UNITED STATES PATENT AND TRADEMARK OFFICE

APPLICATION NO.	FILING DATE	FIRST NAMED INVENTOR	ATTORNEY DOCKET NO.	CONFIRMATION NO.
09/806,304	03/29/2001	Alain Brochez	BROC3001/JEK	6723
7590 03/17/2009				
Bacon & Thomas 4th Floor 625 Slaters Lane Alexandria, VA 22314			EXAMINER GARCIA, ERNESTO	
			ART UNIT 3679	PAPER NUMBER
			MAIL DATE 03/17/2009	DELIVERY MODE PAPER

DETAILED ACTION

Fig. 3

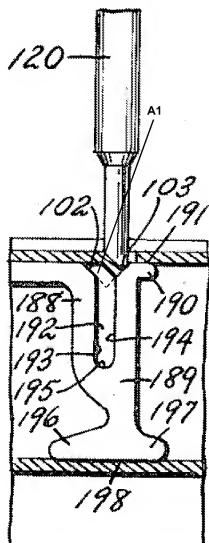
further includes locking means **108, 110** for mutual interlocking the corner piece **16** to the side members **12, 14**. The locking means **108, 110** comprise lips **108, 110** defined by a pressed-in material part of the outer wall **18, 48**. The lips **108, 110** cooperate with notches **A1** (see marked-up attachment) defined on the corner piece **16**. Each of the insert parts **74, 76** includes at least one of the notches **A1** comprising a triangular shape defined by a first side **A2** against which the lip **108, 110** is positioned and a second side **A3**. The locking means **108, 110** generates pre-stress as pressure on both side members **12, 14** and tension in the corner piece **16**. The locking means **108, 110** comprises material parts **108, 110** upset by compressing material of the side members **12, 14**. The upset of the material parts **108, 110** has a useful working force on a mitre. A compression force is created in the side members ends by pushing off both side members **12, 14** on the locking means **108, 110**. The corner piece **16** comprises inclined parts **96, 97** defining a pressure zone between the locking means **108, 110** and a place on the inner wall **36, 66** which is situated deeper in the attachment channels **62, 64** so that pressure is between the place and the locking means **108, 110**. The insert parts **74, 76** comprise resilient members **77** connected to one another at an angle (90 degrees). The inclined parts **96, 97** are respectively connected to the free ends of the resilient members **77**. A free space or clearance (between feature 78 and 100) free of massive material is provided on an outside corner of the corner piece **16**. The free space or clearance extends from the locking means **108, 110** to at least the connecting end of the insert parts **74, 76**. The inclined parts **96, 97** create a tensile force in the resilient members **77** since pressure in the inclined parts **96 97** results in a tension in

However, Ekstein, fails to disclose the triangular shape of the notch **A1** defined by a first side **A2** against which the lip **108, 110** is positioned being longer than a second side **A3** over which a free end of the lip **108, 110** is pressed in. Instead, the triangular shape of the notch appears to be symmetrical thus creating an isosceles triangle versus a right angle triangle thus giving the required sides as claimed. Ronnlund teaches, in Figure 3, a triangular shape of a notch **14** being defined by a first side against which a lip **20** is positioned being longer than a second side over which an end of the lip **20** is pressed in to correspond in shape of the notch thus creating a strong joint (col. 3, lines 47-55). Therefore, as taught by Ronnlund, it would have been obvious to one of ordinary skill in the art at the time the invention was made to change the shape of the triangle defined by a first side against which the lip is positioned being longer than a second side over which an end of the lip is pressed in.

Attachment: one marked-up page of Ekstein, 3,797,194
